### STAFF RECOMMENDATION

1419 Holly Street

March 21, 2012

**Application:** Infill and Demolition

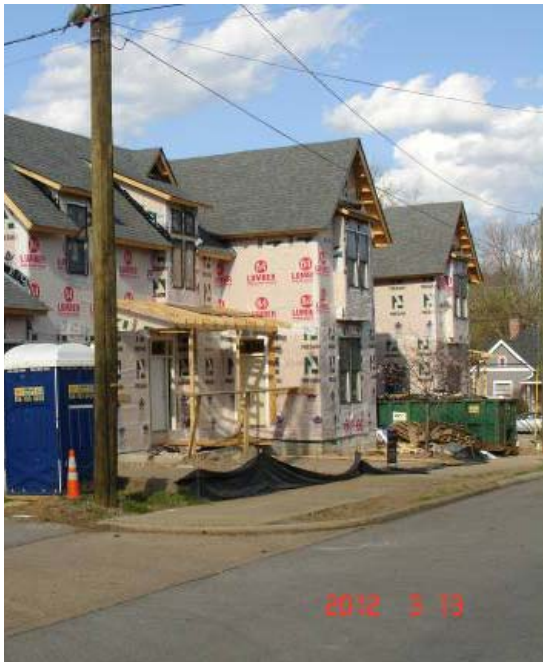
Staff recommends infill duplexes be designed as one large building, as historically seen in the neighborhood, rather than as two units attached with a central garage. Examples include:

A1 ARCHITECTURAL SITE PLAN

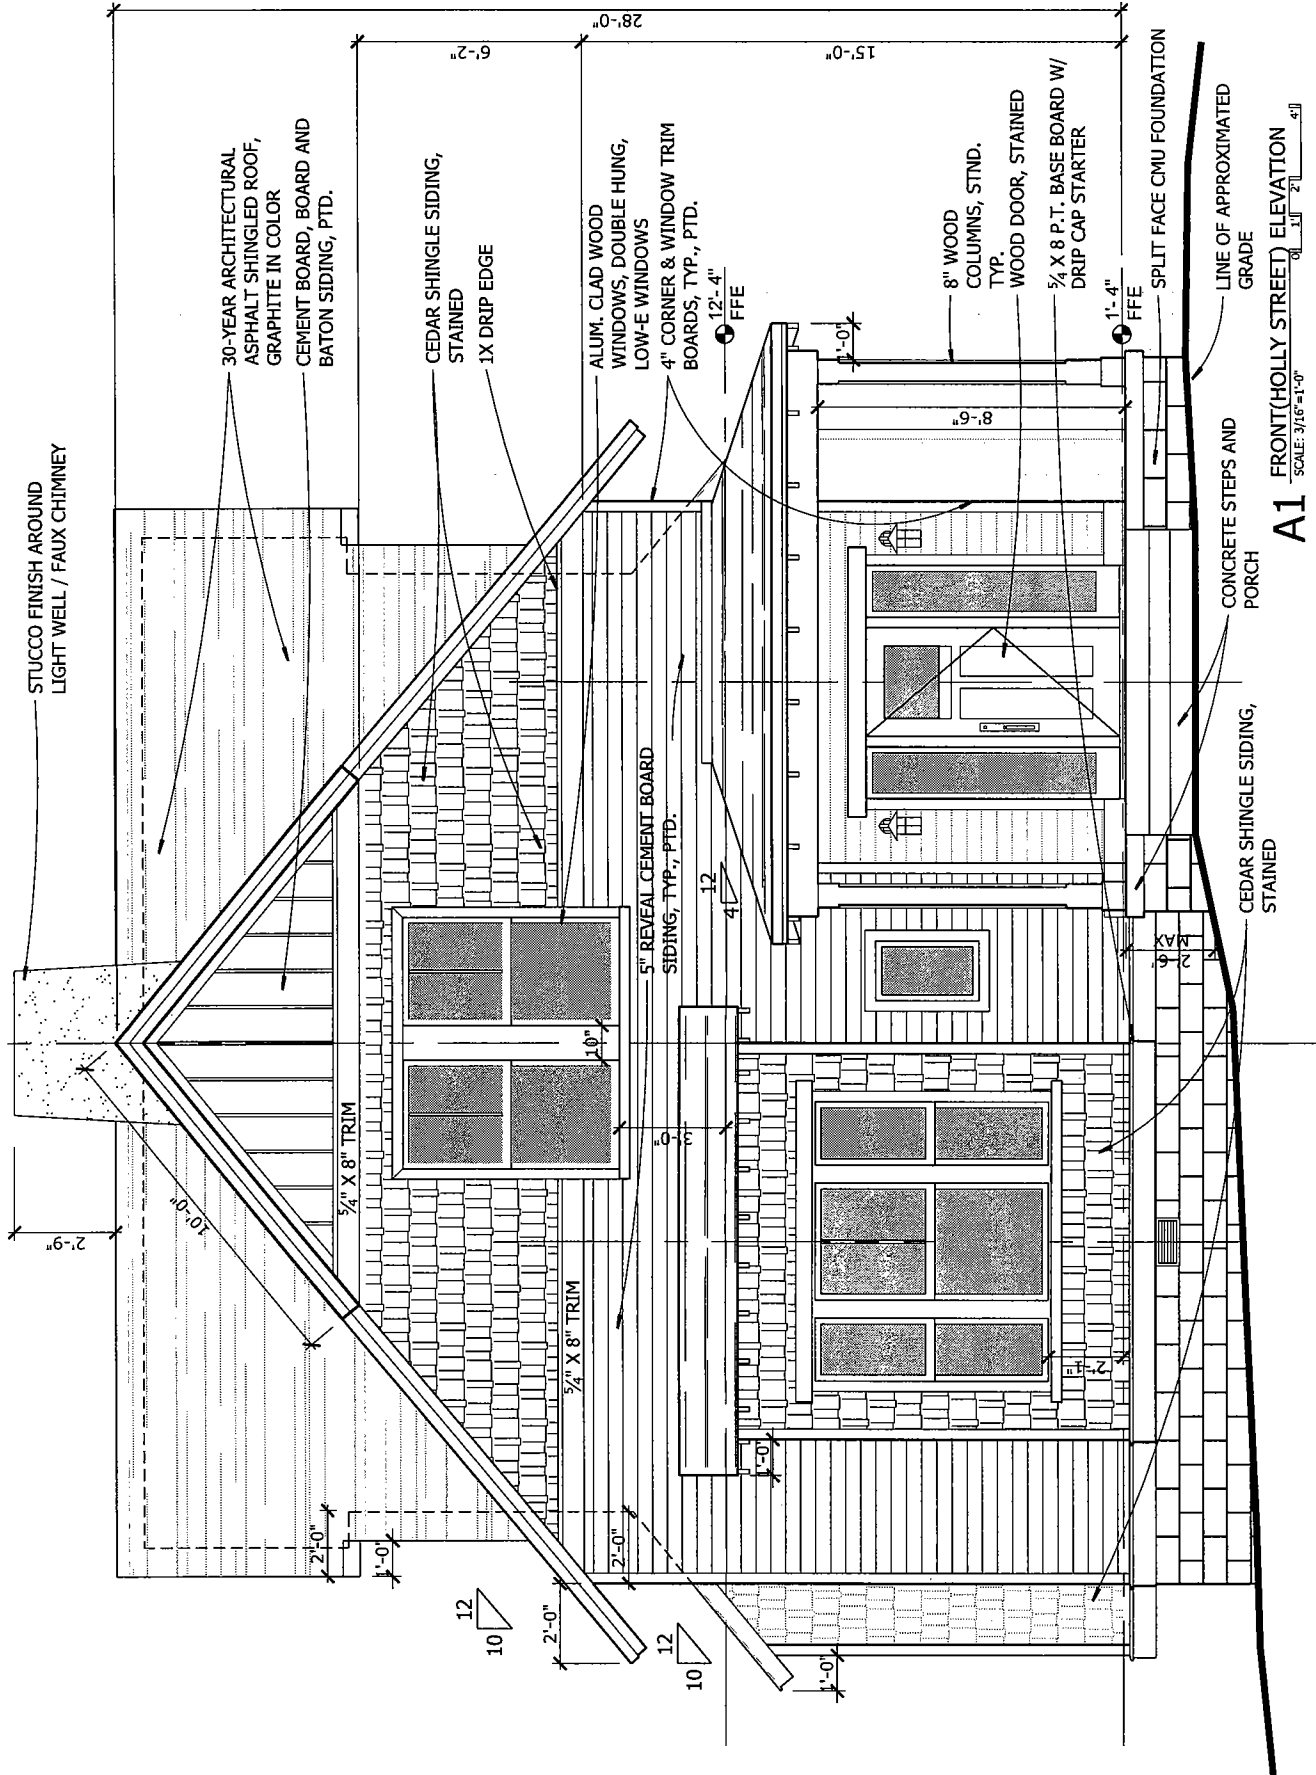
The proposed duplex meets bulk zoning requirements and covers thirty-six percent (36%) of the lot. The typical lot in the immediate context has a coverage of approximately fifteen to 25 percent (15%-25%). Because both the lot coverage and the height of the building exceed the context and because design elements accentuate the height, the height scale of the project is inappropriate and does not meet sections II.B.1 and 2.

The width of the historic buildings in the area range between thirty and thirty-five feet (30'-35') and the homes are roughly centered on the lot. The width of the proposed home is thirty feet (30'), not counting a left protruding bay and the right wrap-around porch. The building is slightly shifted to the interior lot line to meet the required side-street setback. The project meets all bulk zoning requirements.

Vehicular access for the project is with a driveway leading from the alley to a two-car garage and a double-wide (16') driveway leading from North 15th Avenue to a two-bay garage. Typically, the commission does not allow for street-facing garages nor attached garages.

The design guidelines state that garages visible from the street should be located in historically appropriate locations. For this neighborhood, historic garage locations are near the alley, when present. One of the proposed garages is in the middle of the lot and faces North 15<sup>th</sup> Street.

Because of the location, attachment and visibility of the North 15<sup>th</sup> Street garage, the project does not meet section II.B.8.

**A1** PARTIAL SIDE ELEVATION (N 15TH STREET)  
SCALE: 1/8"=1'-0"

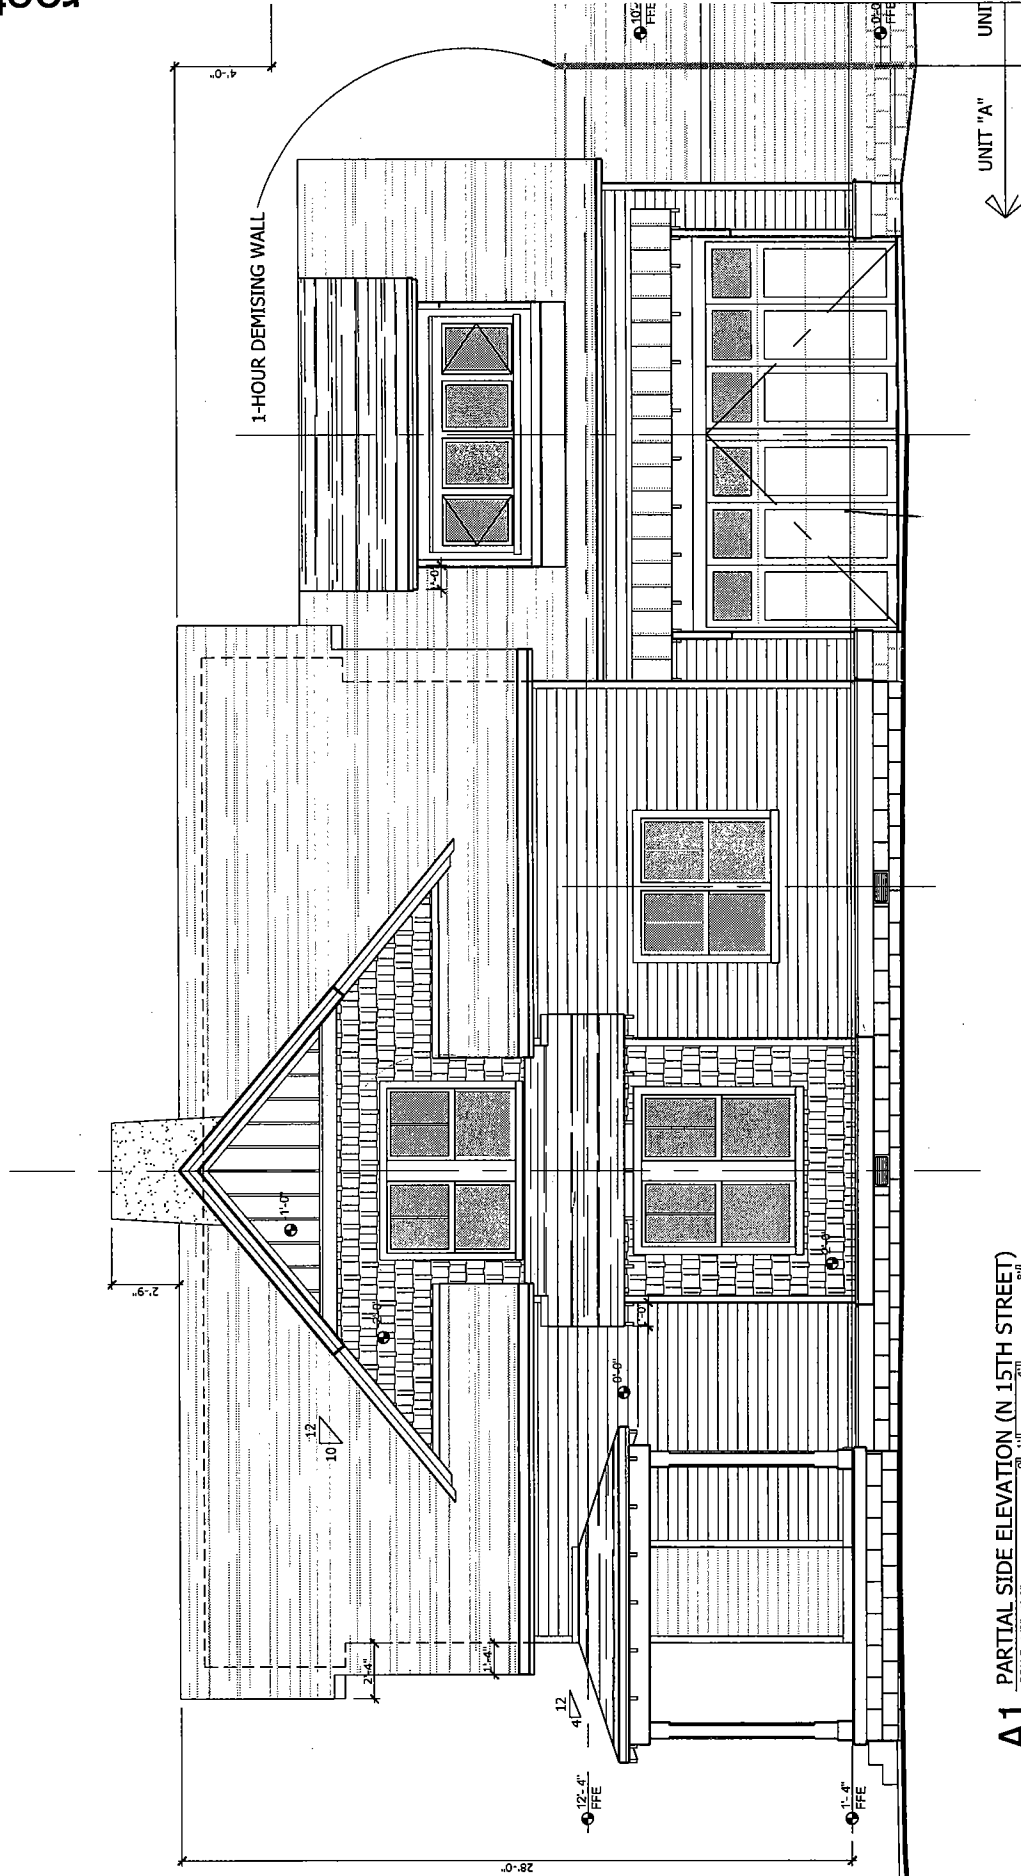
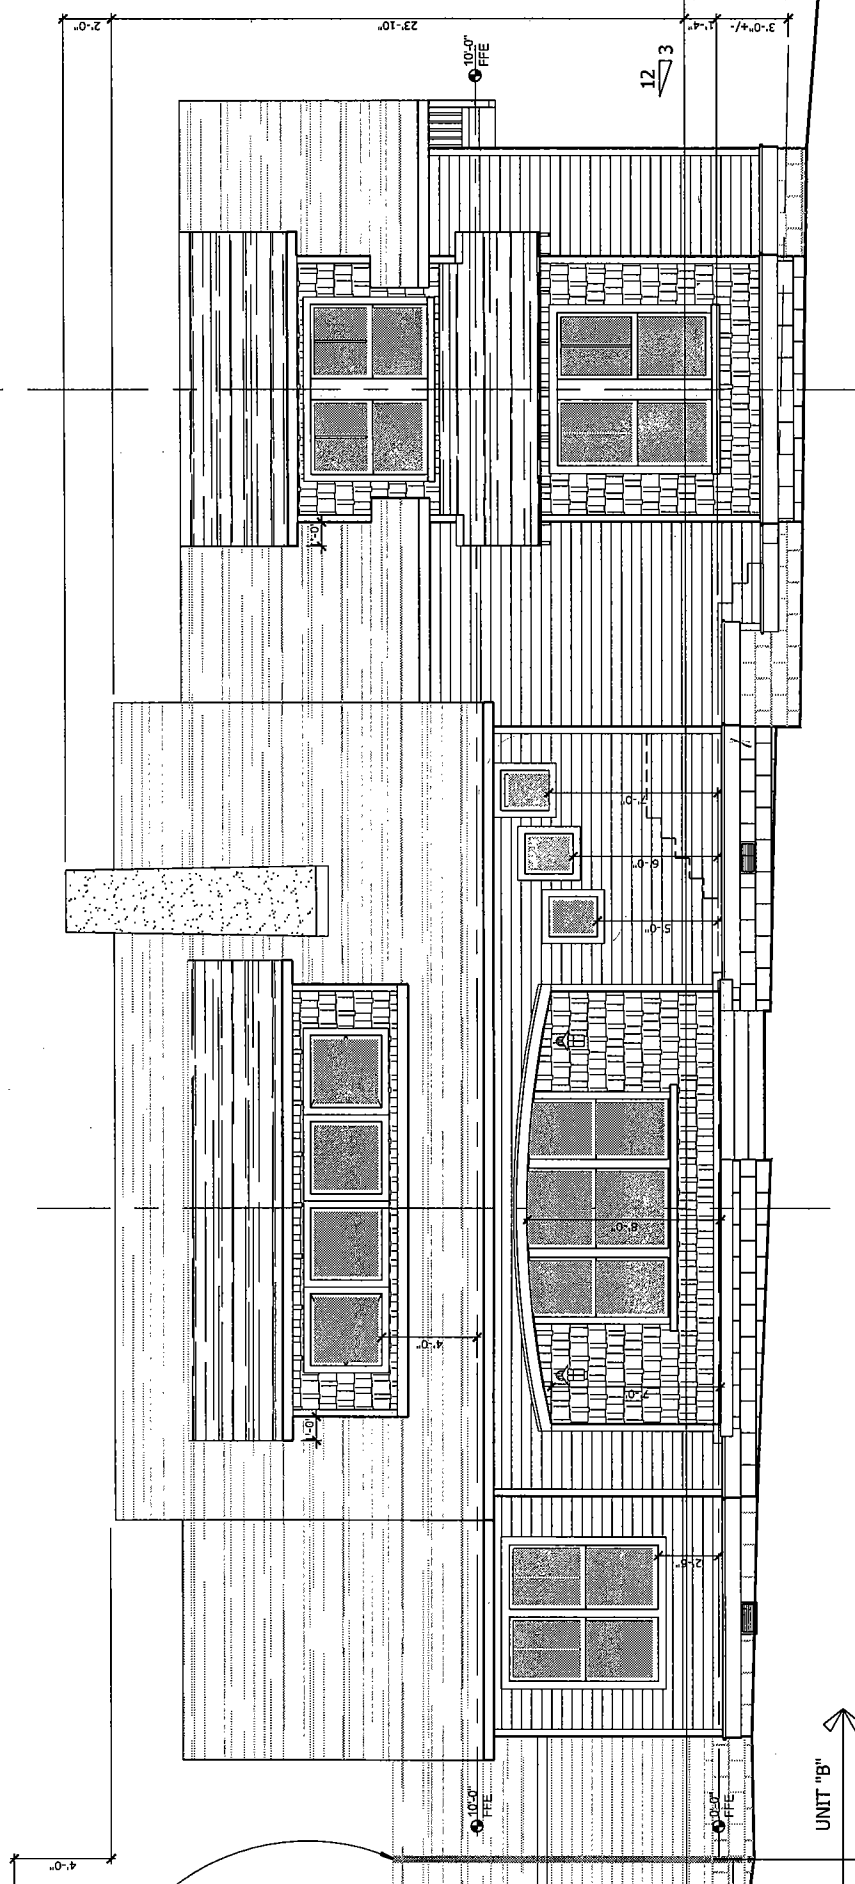
The rear unit has a six foot (6') deep porch that faces North 15<sup>th</sup> Street but the entrance is to the side of the porch and does not relate to the street. In addition, the porch does not sit out from the body of the house and has an enclosed design that further pulls it into the body of the house. Usually, historic porches are sit out from the house.

The majority of windows meet the requirement of being twice as tall as they are wide. Many of the openings, but not all, match the rhythm of solids-to-voids found in the district. The Commission has typically required openings to be no further apart than between eight and thirteen feet (8'-13'); however, on the left side are two large expanses of approximately twenty feet (20') without an opening or other type of wall break. In addition, there are several areas exhibiting small stair-stepped windows. This type of window configuration is not found in the district. Staff finds that the large expanses of solid walls and the stair-stepped windows do not meet section II.B.7.
